## HISTORIC AND DESIGN REVIEW COMMISSION

July 15, 2015 Agenda Item No: 21

HDRC CASE NO:	<b>2015-268</b>
ADDRESS:	123 MAY
LEGAL DESCRIPTION:	NCB 1373 BLK 1 LOT 18 19 E 27 FT OF 17
ZONING:	RM4 H
CITY COUNCIL DIST.:	2
DISTRICT:	Dignowity Hill Historic District
DISTRICT:	Dignowity Hill Historic District
APPLICANT:	Loren Drum
OWNER:	Christina Vidal, Carlos Vidal
TYPE OF WORK:	Construct detached storage/shop outbuilding

# 117 May - Main House

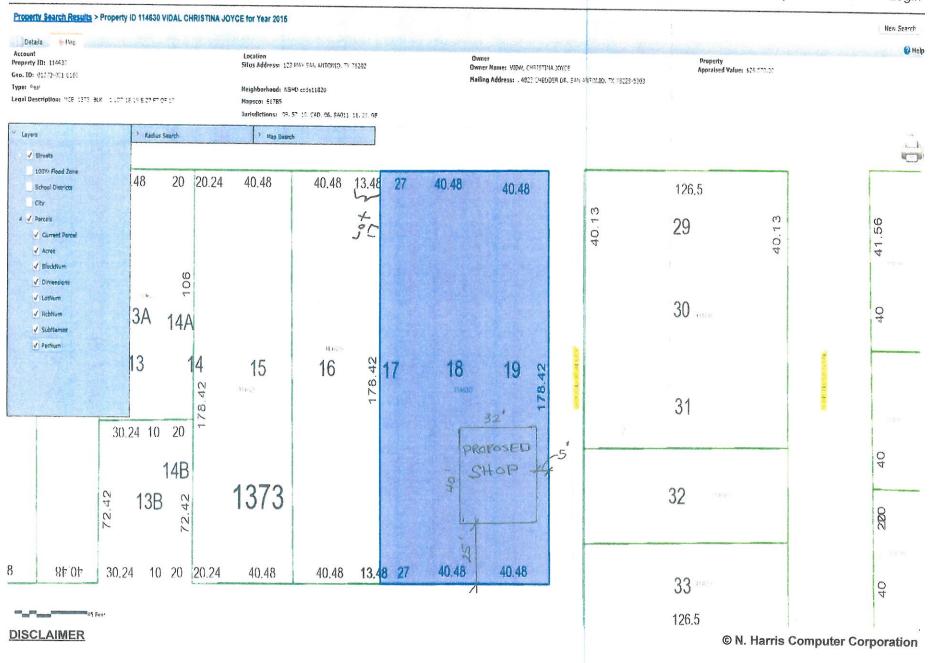
- b. The property is currently subdivided in multiple lots. The only existing structure is the house at 117 May. The existing house is built in the Minimal Traditional style with a low pitch hip roof, deep overhangs, and plank siding.

- d. According to the Guidelines for New Construction, new garages should relate to the period of construction of the principal building on the lot through the use of complementary materials and simplified architectural details. The proposed structure does not relate to the Minimal Traditional style of the main house in roof form, pitch, and overhang dimension which is not consistent with the guidelines.

- a. New structure should relate to style and period of construction of the main house
- b. Reduce height to be more consistent with surrounding structures
- c. Garage should be located towards the rear of the property behind the main house.
- d. Additional information including window specifications, foundation type, and dimensioned site plan is submitted for review so that drawings demonstrate 80% completion as required by the UDC.

LVIDAL NOME - PROPOSED BARN /STORAGE BLOG

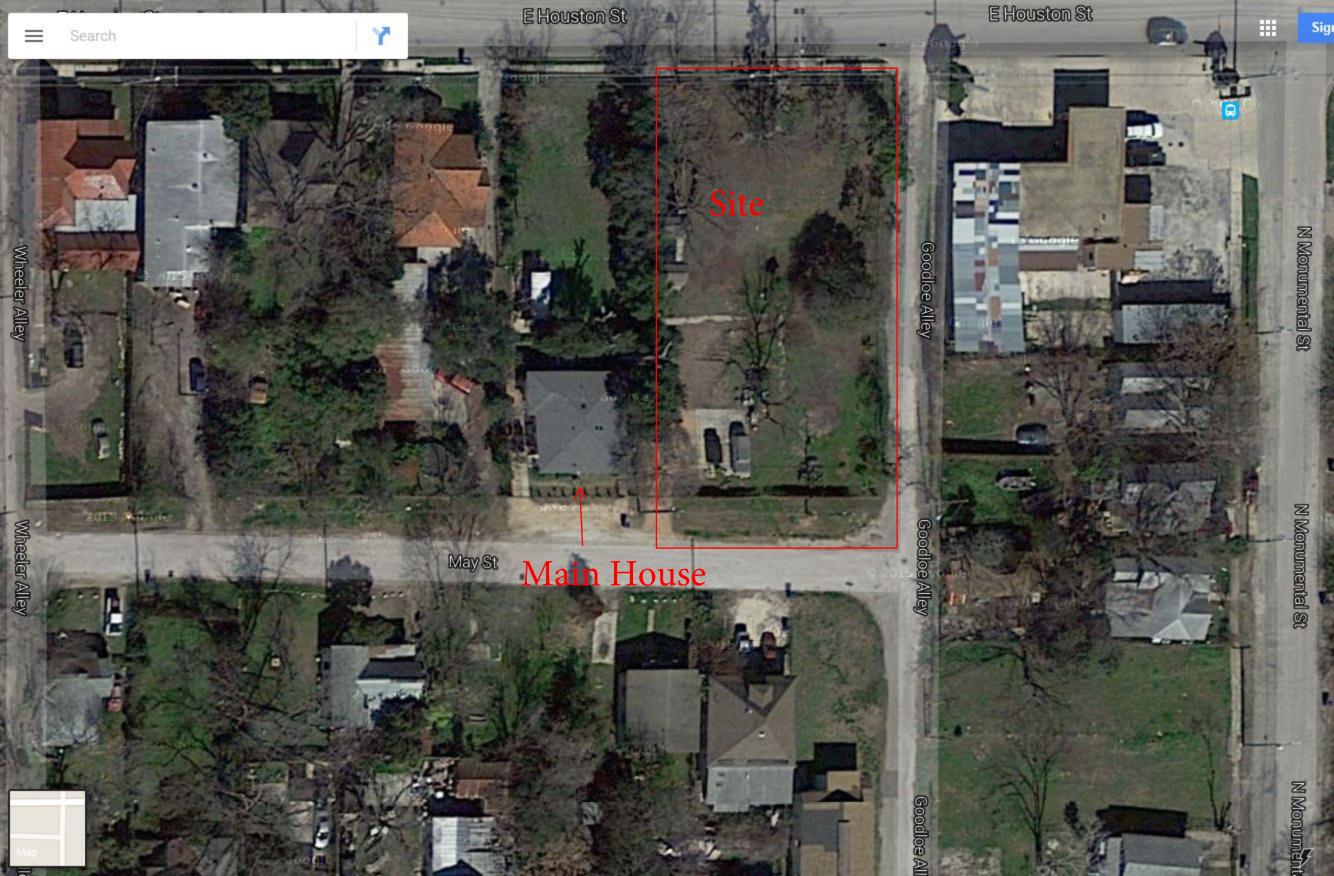
- c. Consistent with the Guidelines for New Construction, new outbuildings should be visually subordinate to the principal historic structure in terms of height, massing and form. The proposed structure will be taller and appear larger than the main house; however it will be located on the opposite side of the property which will reduce the appearance of height compared to the main house. Although the proposed garage will be surrounded by mostly vacant lots, the existing adjacent structures are one and one-half story houses along Goodloe Alley and across May Street. Due to its location on the site and surrounding context, additional height may be appropriate.

- e. As recommended by the Guidelines for New Construction, windows and door openings should be similar to those found on historic garages or outbuildings in the district or on the principle historic structure in terms of their spacing and proportions. The proposed design is consistent with the guidelines.

- g. Consistent with the Guidelines for New Construction, the historic setback pattern of similar structures along the streetscape or district should be followed. Historic garages and outbuildings are most typically located at the rear of the lot, behind the principal building. The proposed garage will be located on the front yard of the property and will align with the front of the main structure which is not consistent with the guidelines.

Staff does not recommend final approval at this time based on findings a-g. Staff recommends the following:
